## ***Pierre Auger Observatory***

# **Surface Detector Electronics Upgrade UUB Pre Prototype Production Report**

*UUB Model version:* SDE-002-002-IE00

<i>Document written by:</i> E. Lagorio	<i>verified by:</i> P. Stassi
<i>Institute:</i> LPSC Grenoble	
<i>Date:</i> 24 November 2016	<i>Date:</i> 19 November 2016
<i>ATRIUM Reference:</i> 120770	<i>Project Reference:</i> WP05-LPSC-20D

Figure 30: R297\_7 pull\_up resistor power supply on (Schematic page 12).

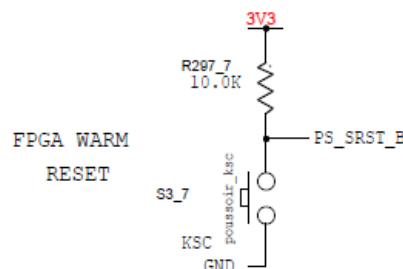
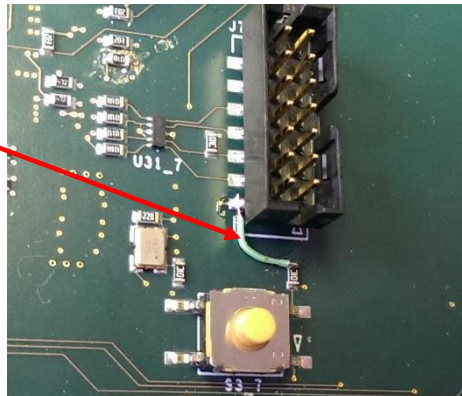
3,3 Volts is missing on Slow-Control Reset Pull-up R297\_7 resistor. One pin is unconnected. It must be connected to 3,3 Volts power supply.

A wire must be connected from R297\_7 resistor pin to the J7\_7 connector pin 2 (3,3 Volts) (NCR n° 2-49).

Figure 32: Pull-up resistor added on watchdog output (Schematic page 12).

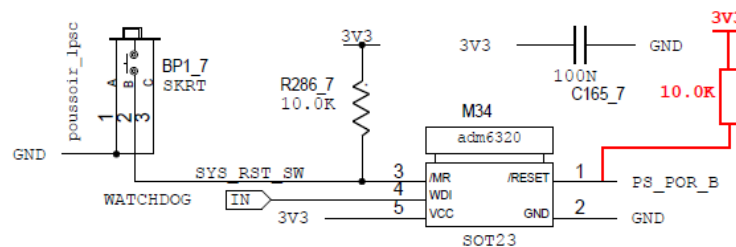
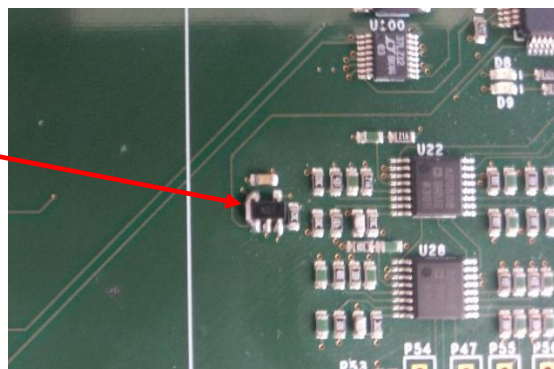
A pull-up resistor is missing in the schematic. A 10 kOhms resistor must be added between 1 and 5 pins for M34 components (NCR n° 2-22).

Figure 34: SCL & SDA wires must be swapped (Schematic page 7).

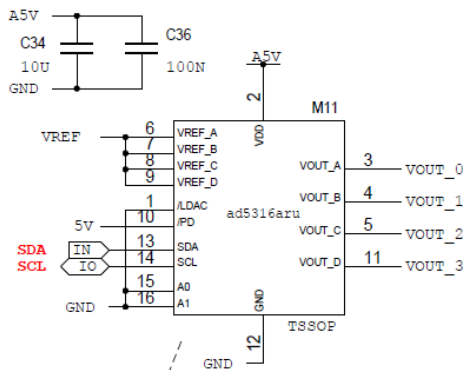
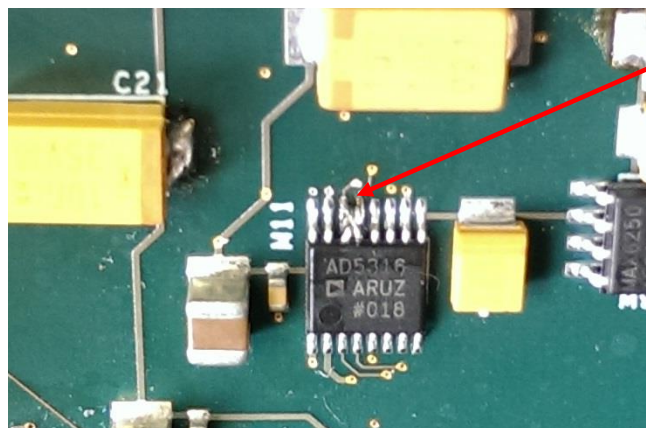
Error in the schematic, SCL & SDA pins must be swapped.

Figure 36: SCL & SDA wires must be swapped on board

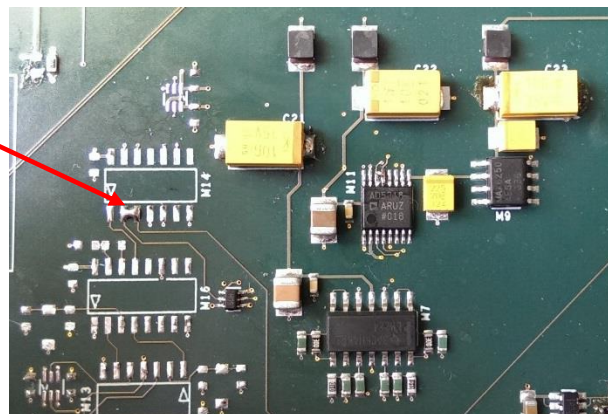
A short-cut must be made between M14 pins 2 and 3.

Figure 37: OFFSET\_1 C5\_3 decoupling capacitors in wrong place (Schematic page 18).

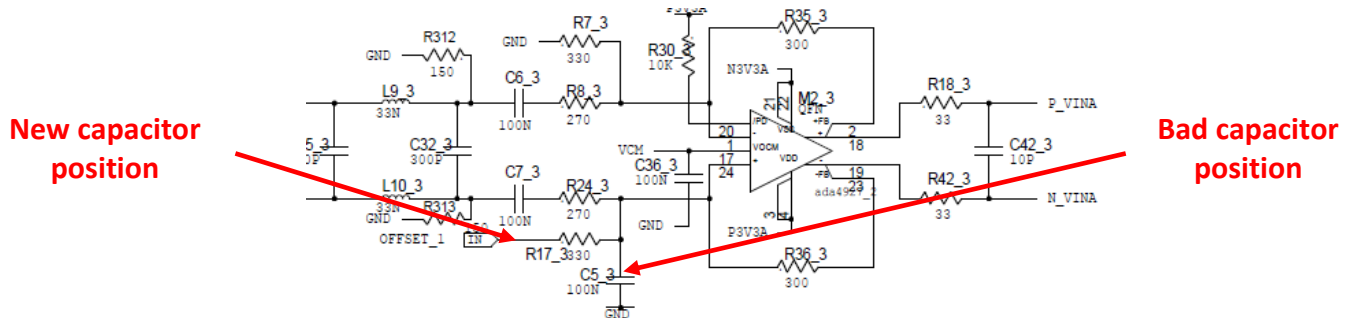
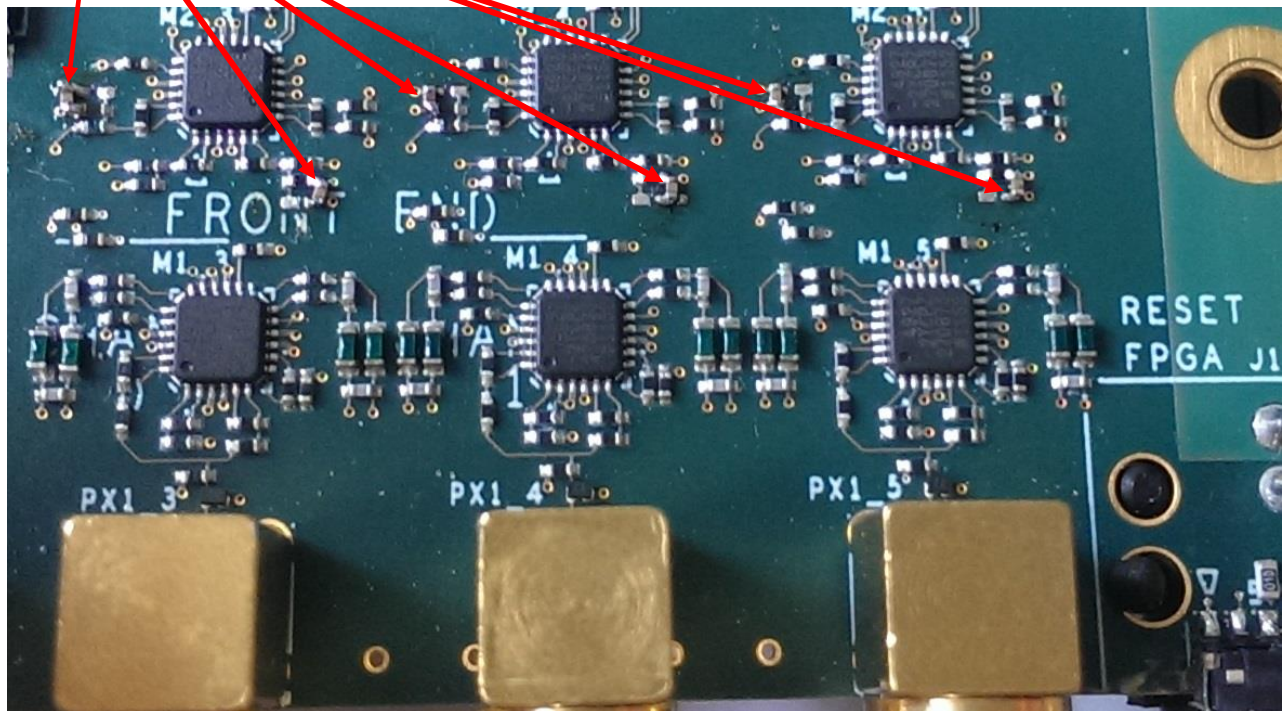
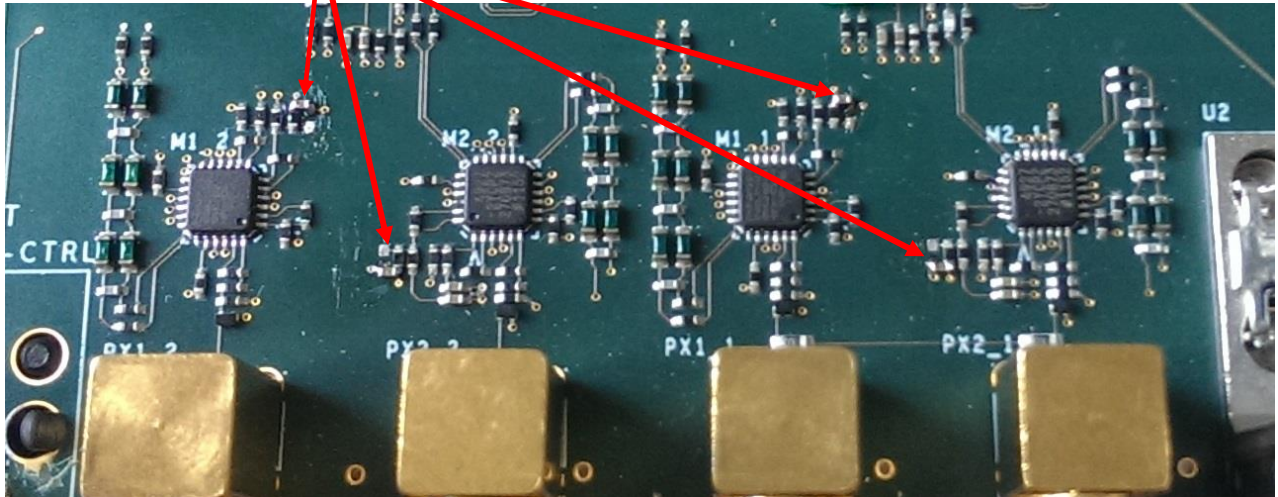
Offset 1 & 2 decoupling capacitors are in the wrong position in the schematic. These capacitors are: C5\_1, C8\_1, C5\_2, C8\_2, C5\_3, C8\_3, C5\_4, C8\_4, C5\_5 & C8\_5.

Figure 40: OFFSET\_1 & OFFSET\_2 amplifiers decoupling (Schematic page 15).

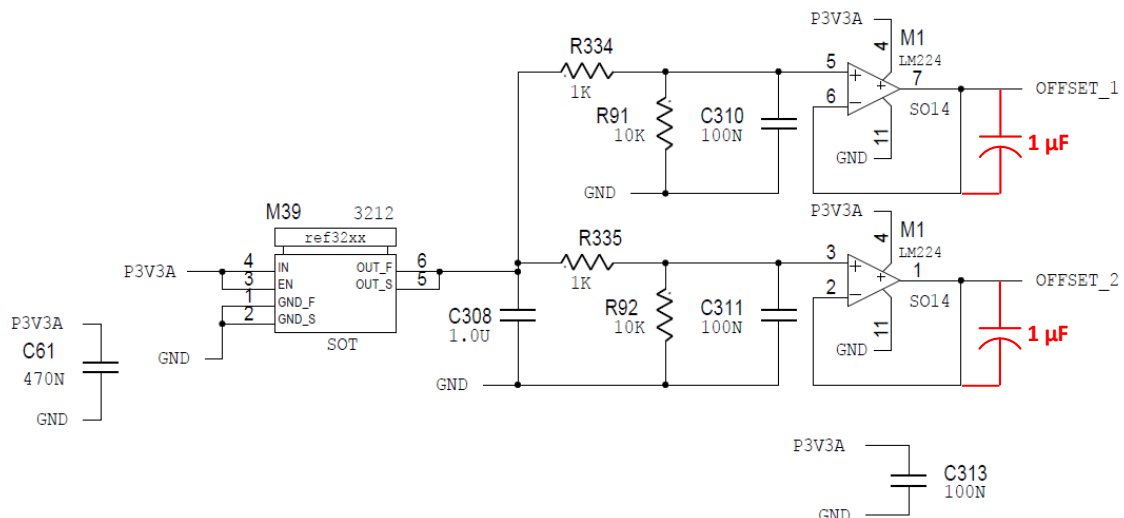
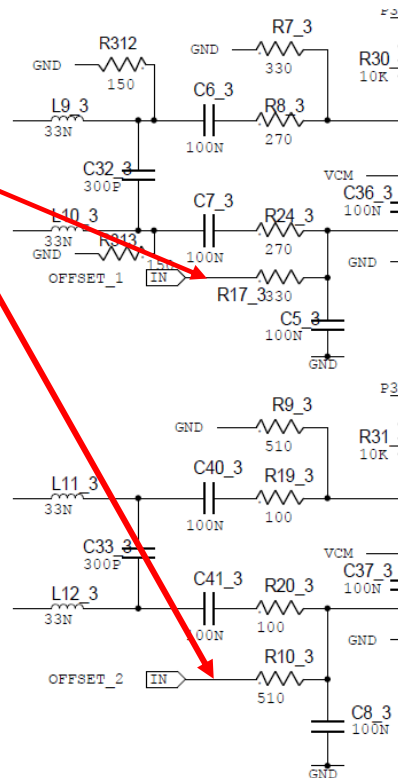
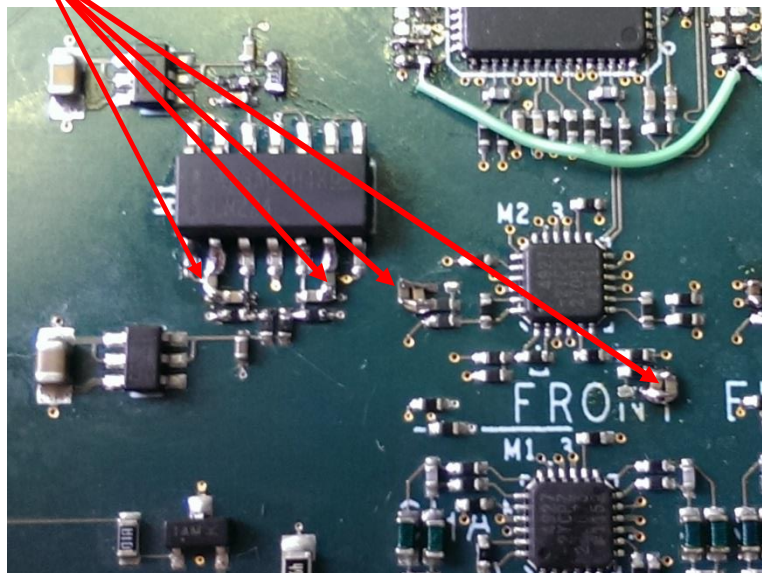
4 Tantalum or ceramic decoupling capacitors must be soldered on board on each OFFSET signal. 2 on amplifier Offset outputs. The 2 others must be close the ADCs.

Be careful with the capacitor's polarity, it is a Tantalum technology.

Figure 43: Disconnected Vref provided by M1 amplifier (Schematic page 15).

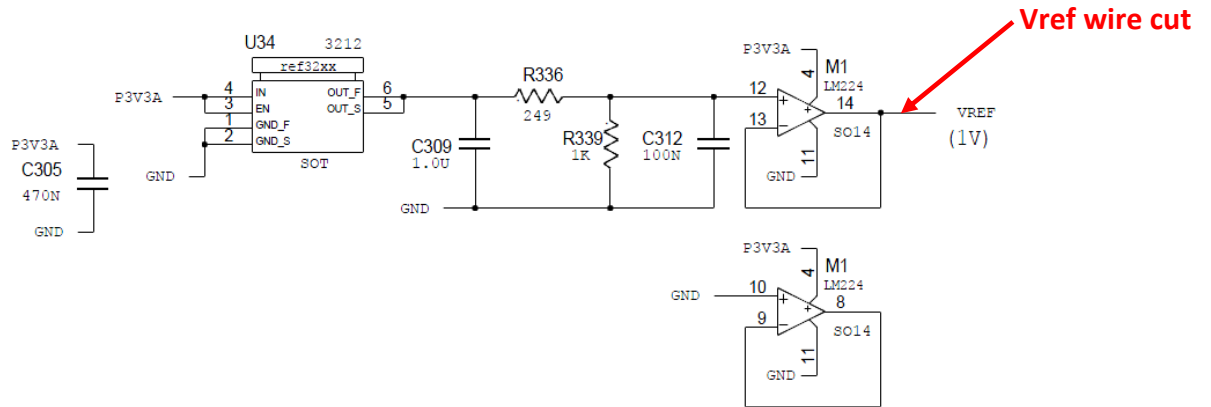
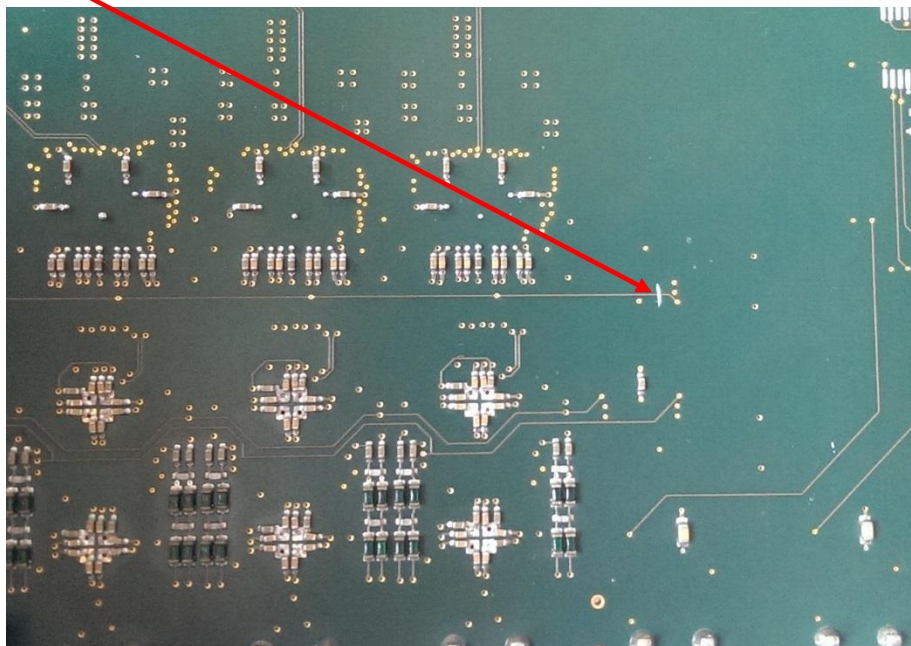
Vref wire provides 1 Volt to all ADCs. A wire cut must be made just after the M1 output pin.

Figure 45: SSD analog input Wire Cut.

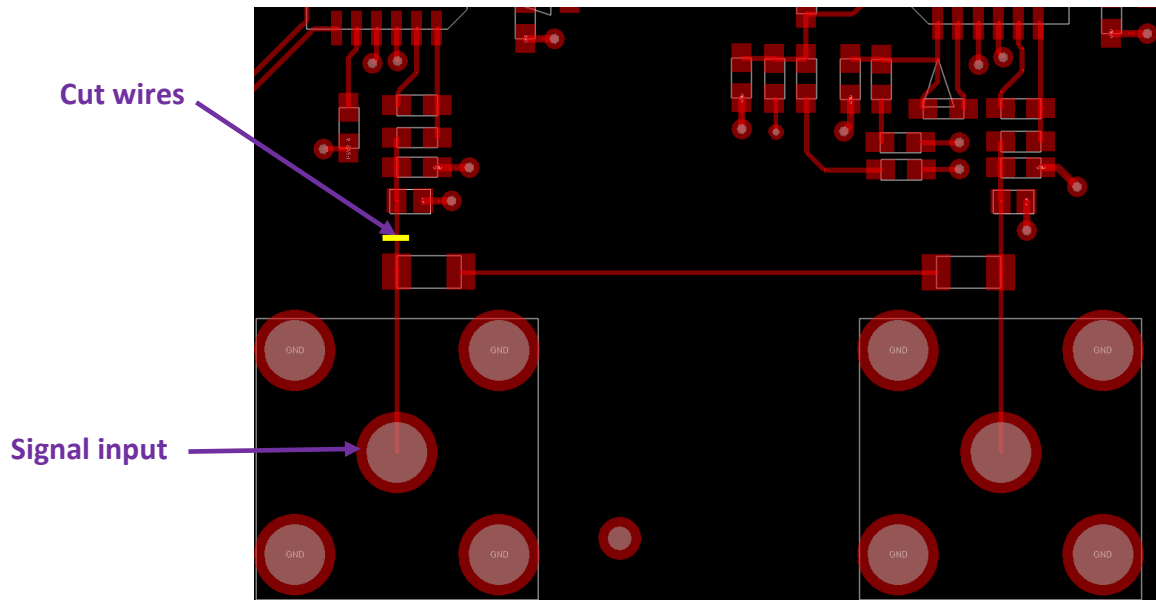
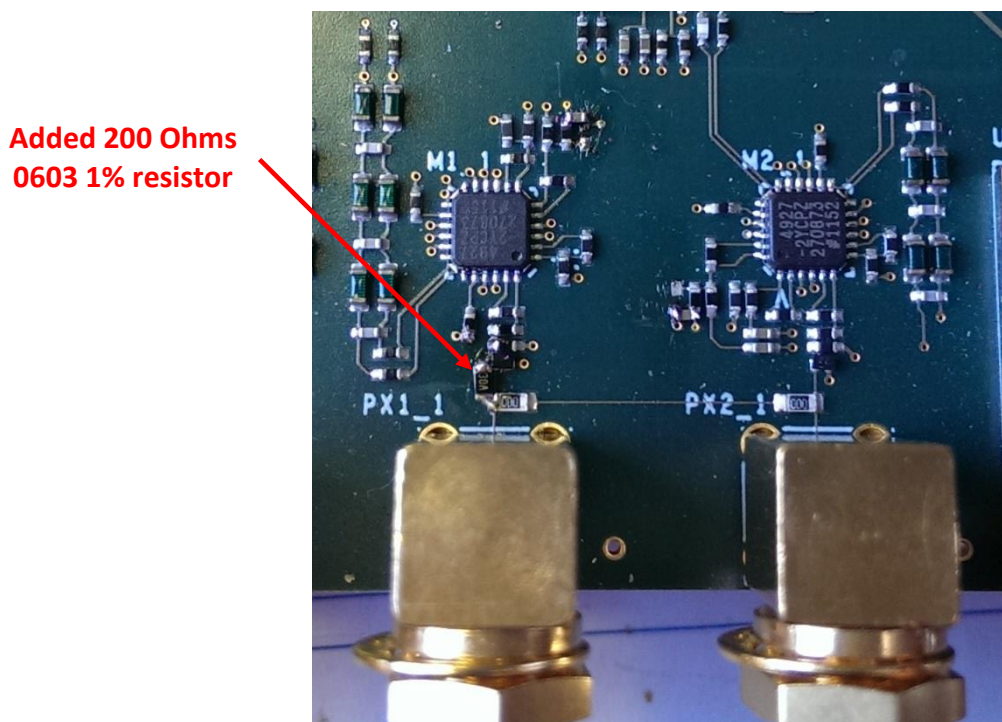
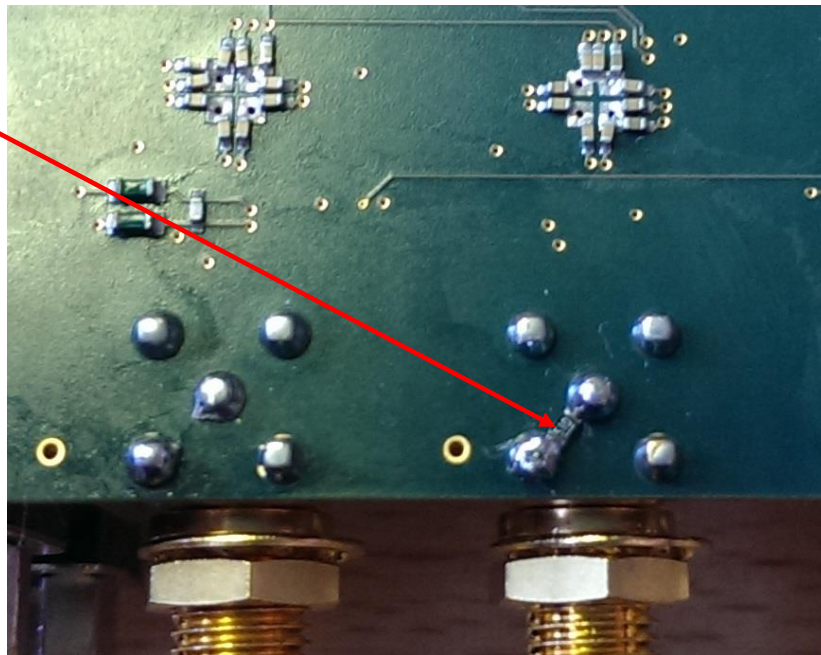
For SSD detector the type 3 front-end design must be implanted with a type1 Bill Of Material. For the impedance adaptation a wire must be cut and a resistor 200 Ohms and 51 Ohms 0603 package added.

Figure 48: New resistor value for R91 an R92 (Schematic page 15).

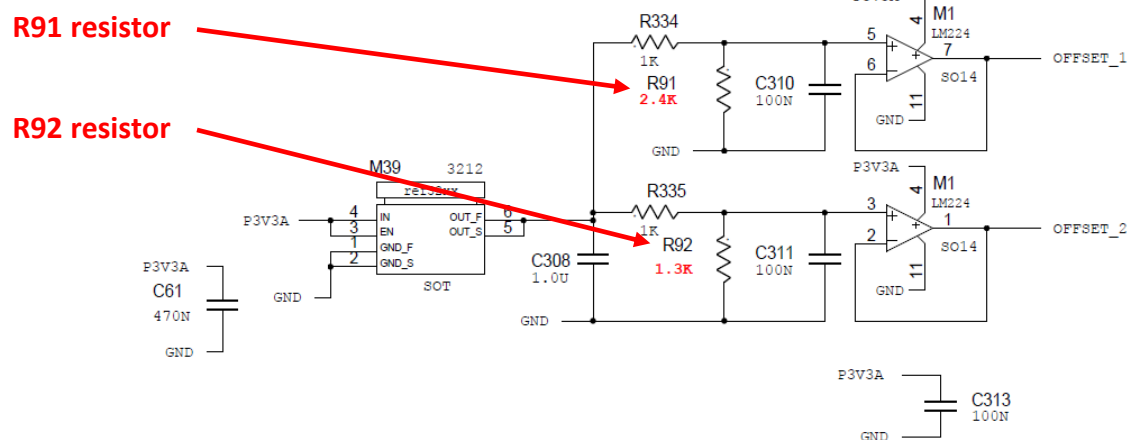
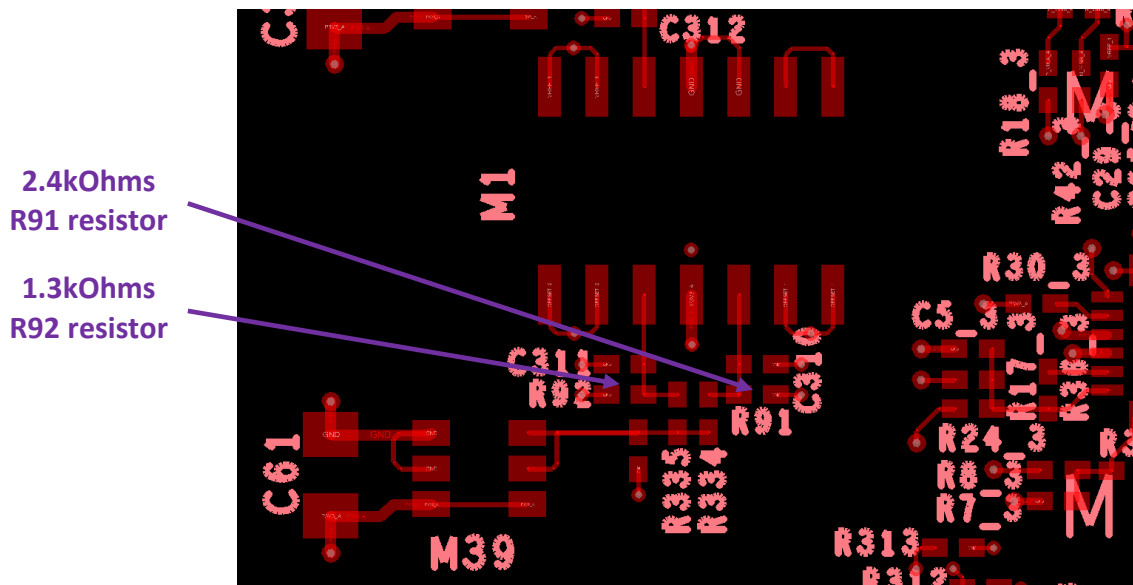
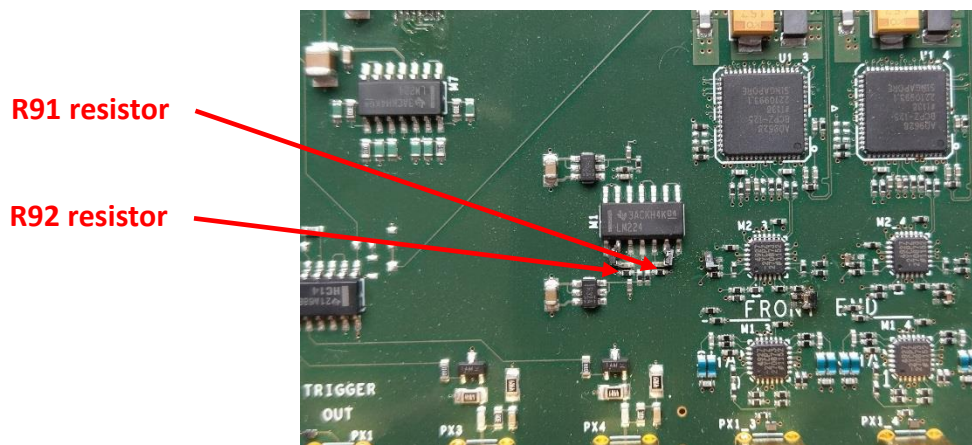
The Reference Voltage value must be changed. R91 resistor value must be 2,4 kOhms and R92 1,3 kOhms in 0402 1% (NCRs n° 2.-47 & 2-48)

Figure 51: Removed U49 & U50 ESD RCLAMP components.

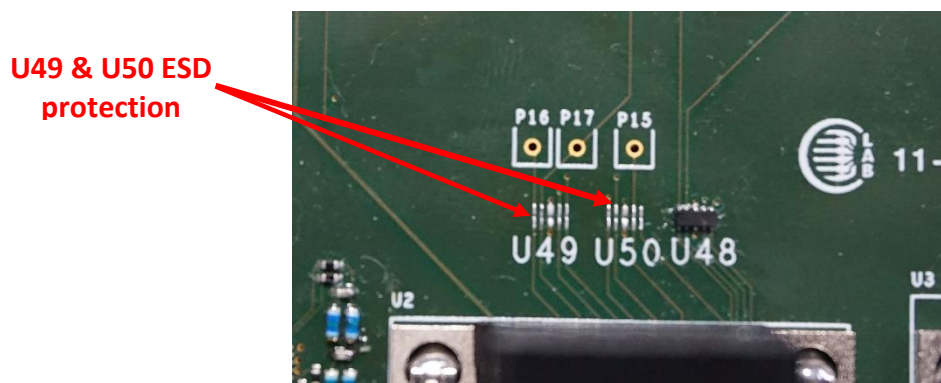
The RCLAMP0524J.TCT ESD component modifies the "Radio RS232" signal. The U48 & U50 must be removed. The MAX3218 RS232 interface has already 15kVolts ESD protection.
